# **802.3ck D2.2 Comment Resolution 163, 163A, 163B**

Phil Sun, Credo  
Howard Heck, Intel

Figure 163A-3—Configuration for transmitter reference transition time

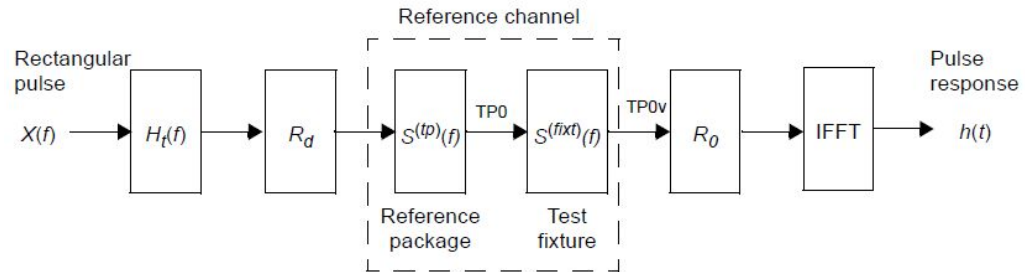
Equation 163A-2 includes a BT filter,  
but Figure 163A-3 does not.

Following up on unsatisfied comment #21 against D2.1 it seems that the filter is indeed missing from Figure 163A-3. If the calibration of the ITT in 120F becomes aligned to 163 (subject of another comment), then the editor's note in 163A.3.1.3 will be addressed.

As a result of resolution for comment #73 on D2.1, the observation filter (i.e. BT4 filter) was removed from the measurement of transmitter transition time for RX interference tolerance test in clause 163.9.3.5, step e. Therefore, the observation filter should be removed from the calculation of transmitter reference transition time. Besides, Figure 163A-3 should include the step response.

In Figure 163A-3, change  $h(t)$  to  $h_{noBT}(t)$ . After  $h_{noBT}(t)$ , add a block of Equation (163A-5) (or just a capital Sigma) followed by  $u_{noBT}(t)$  with a label of "Step response".

PROPOSED ACCEPT IN PRINCIPLE.

Implement the suggested remedy with editorial license.
